CITY OF CHICO
ARCHITECTURAL REVIEW AND HISTORIC PRESERVATION BOARD
AGENDA

REGULAR MEETING OF MARCH 2, 2016
Municipal Center - 421 Main Street - Conference Room 1
4:00 p.m.

Architectural Review and Historic Preservation Board Agenda Report

RE: Surf Thru Express Car Wash – Vacant Lot at Southwest Corner of Forest Avenue and Notre Dame Blvd. – APN 002-190-038

PROPOSED SITE PLAN

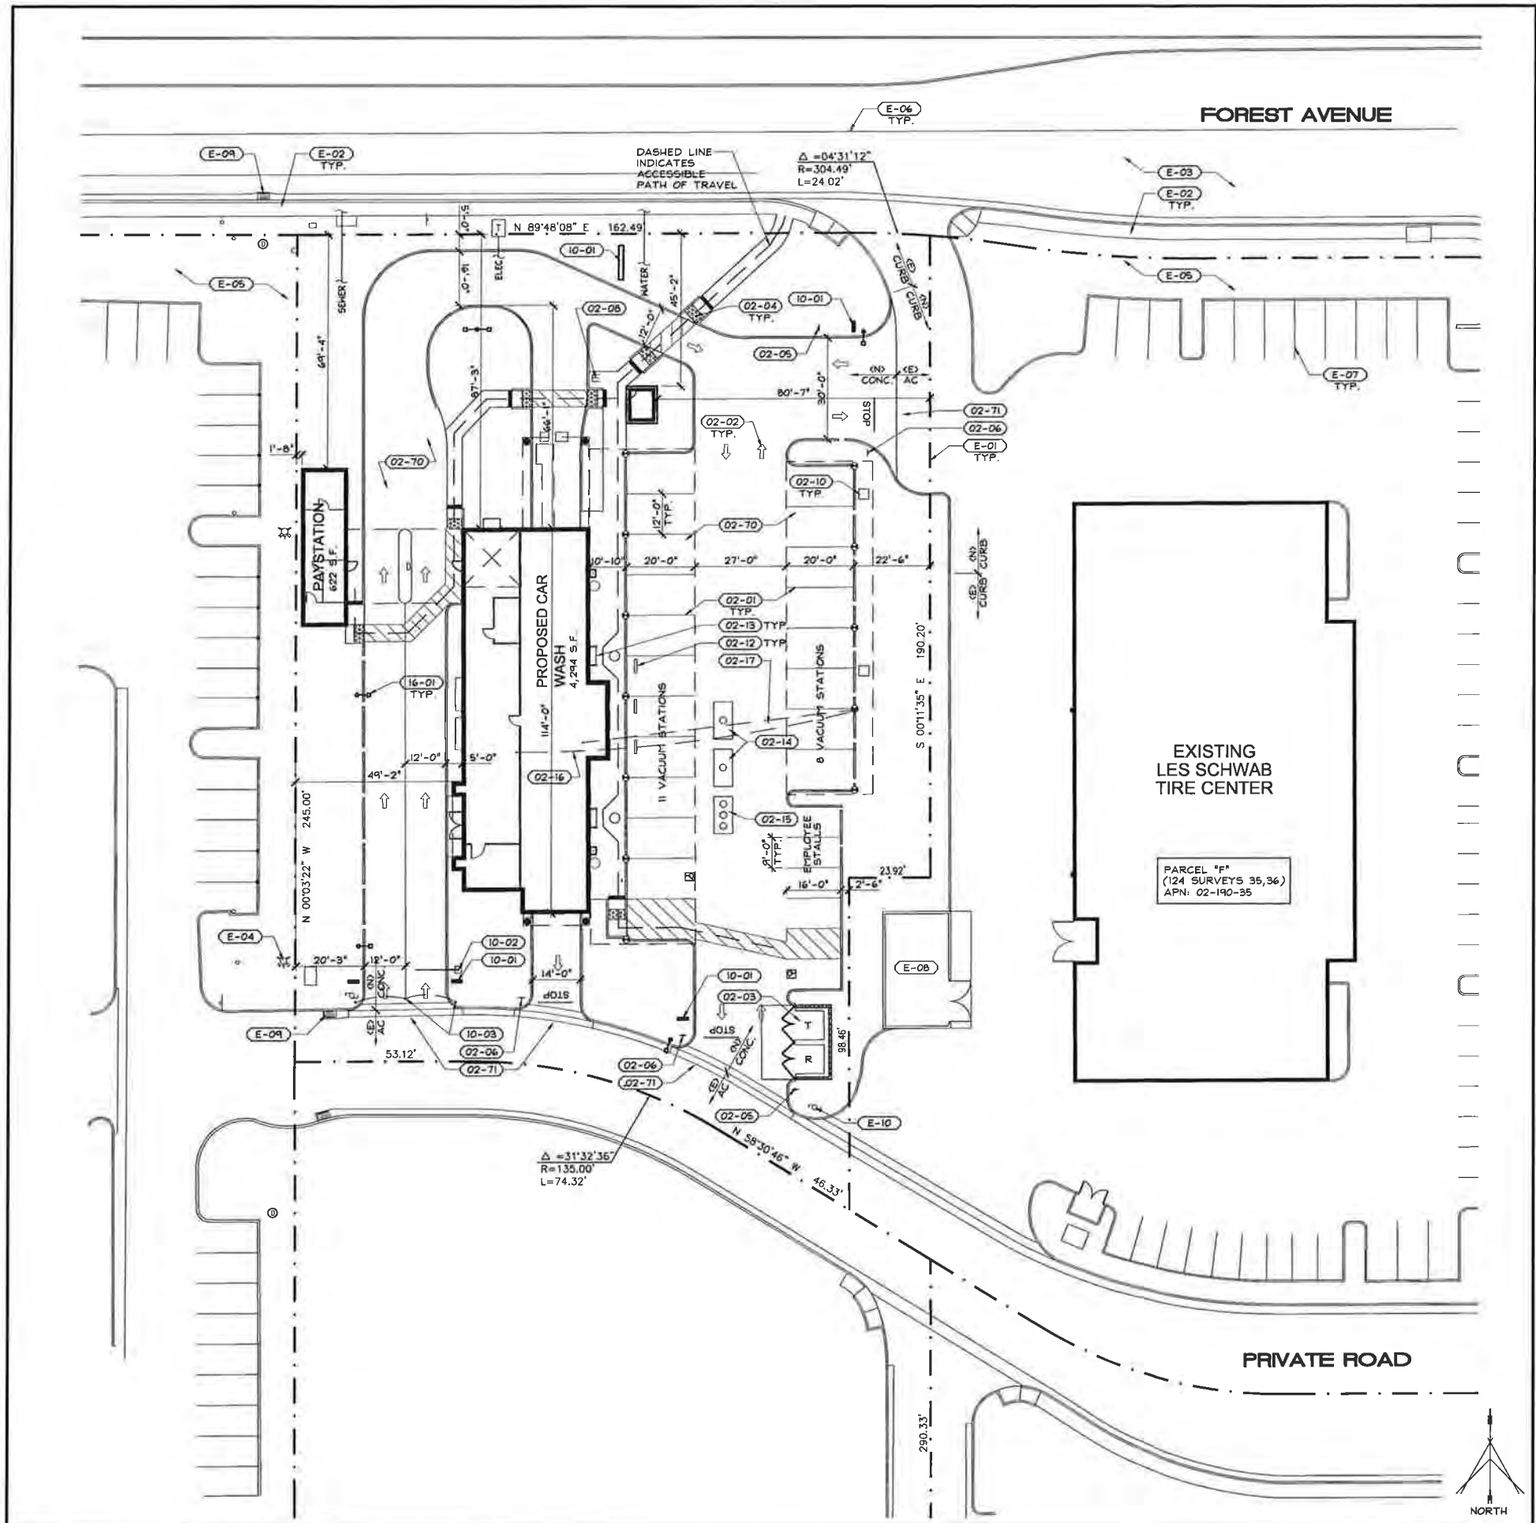
Chico Municipal Code section 19.76.070.G. – *Drive-through Facilities*, requires each drive-through aisle shall be designed to include a combination of landscaping, low walls and or berms to prevent headlight glare and to reduce visibility from impacting adjacent streets. Landscaping is present along Forest Avenue frontage, however, it does not contain a low wall or berm. Staff recommends that the board discuss with the applicant appropriate design modifications to satisfy this code section.

Drive-through Screening
Screening of the drive-through does not meet code requirements which require the combination of landscaping, low walls or a berm to prevent headlights and reduce visibility from the public right-of-way. Staff request that the board discuss with the applicant a design solution to meet code requirements.

Shrubs and/or a two-foot high concrete masonry unit (CMU) wall will be added to block the cueing lines of cars at the entrance end (street side) to the car wash tunnel. Trees and shrubs matching neighboring parcels will be provided in the landscape frontage shielding vehicles from the public right-of-way, quantity and size designed per city code standard. The trash bins will be located within a 6 foot tall CMU enclosure with metal gates, along with necessary landscaping tall enough to soften the trash enclosure walls.

PROPOSED EXTERIOR ELEVATIONS

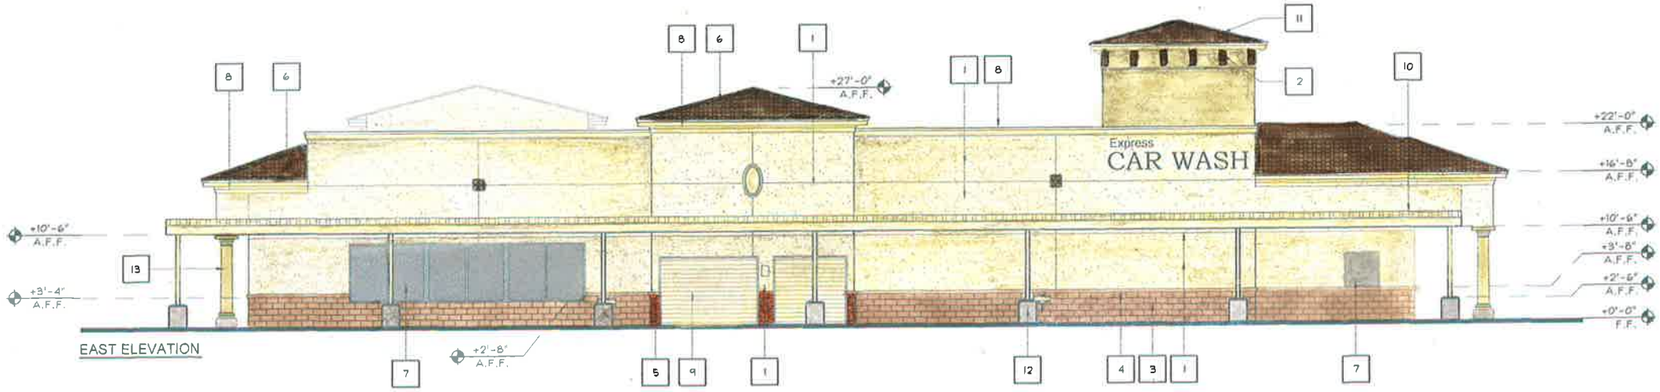
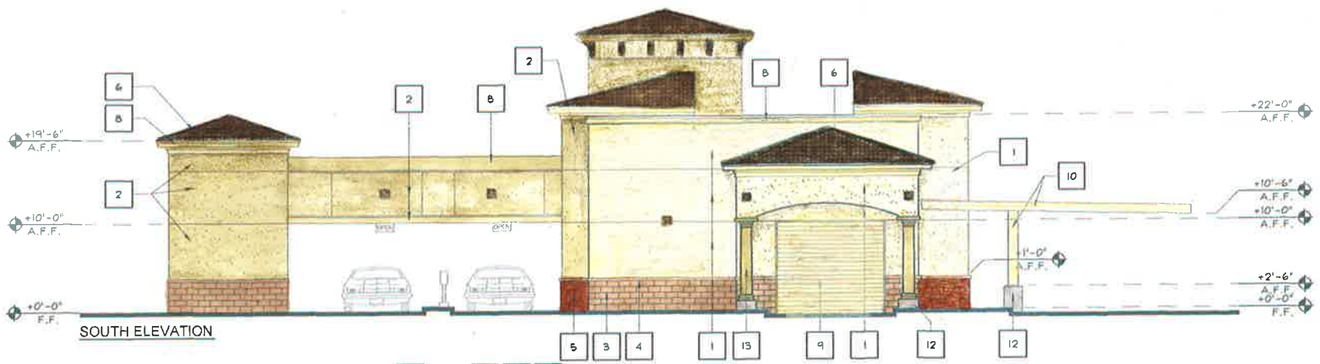
Pay station
Located on the western elevation, the pay station does not contain any window treatments that can be seen from the public right of way. Staff request that the board discuss with the applicant the possibility of including window elements on either the western or northern elevations of the pay station.

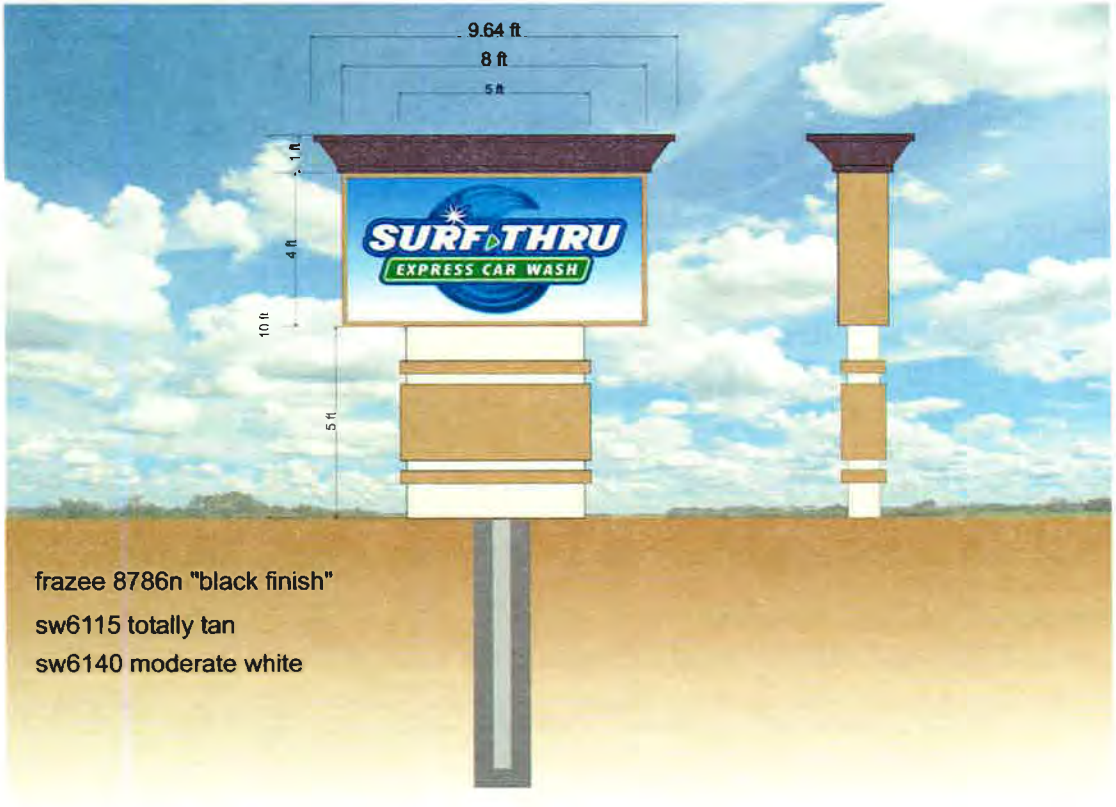
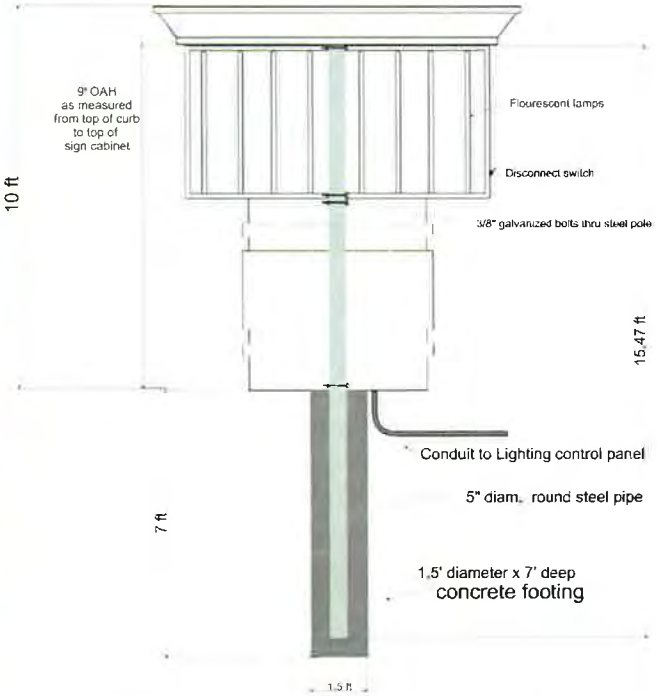
Sign package has been submitted, which notes signage will be internally illuminated flush mounted channel letters (**Attachment G**). Structural signage is proposed on the north elevation, as well as the west and east elevations. A 10-foot tall monument sign is proposed along the Forest Avenue street frontage. Staff recommends that the proposed monument sign not to exceed 6-feet in height and be placed in a dedicated landscape planter per Chico Municipal Code (CMC) requirements. Pursuant to CMC section 19.74 – Signs, a total of 228 square footage of sign area is allowed (2 square foot per 1 foot of linear building frontage) for all signs. The sign proposed exceeds requirements at 289 square footage of sign area. Therefore, staff has placed a condition of approval requiring signage to conform to code requirements and approved by planning staff.

4. Sign package shall be revised to conform to the 228 square footage maximum as set forth in Chico Municipal Code section 19.74. Monument sign not to exceed 6-feet in height and shall be placed in a landscape planter. Future signage shall be reviewed and approved by planning services staff prior to issuance of a sign permit.
